Technical Bulletin

SCM
TURBO

Turbocharger Supersession Update 914553-5002S

Current Design (914553-5002S)

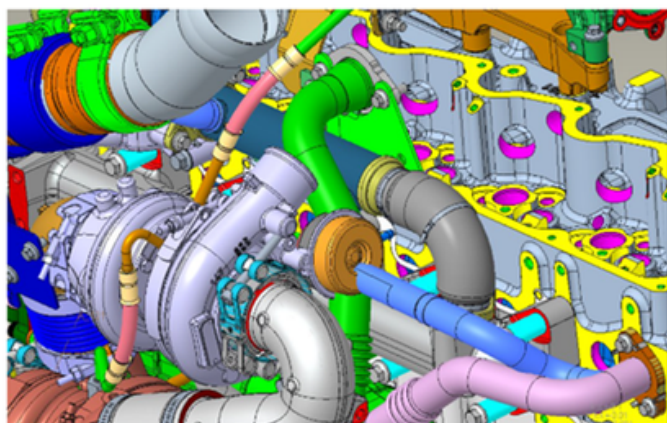
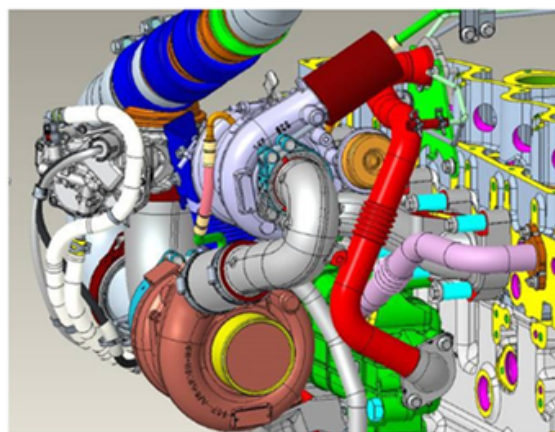
Although the turbocharger orientation remains unchanged, the pneumatic actuator has been repositioned on the latest design.

This change was requested by Perkins and may require the latest OE specification EGR pipe and actuator connector pipe when installing the turbocharger.

Previous Design

Green EGR pipe

Original actuator position

Red EGR pipe

Revised actuator position

Before installing 914553-5002S, verify with a Perkins dealer whether the latest EGR pipe and actuator connector pipe are required for the application.
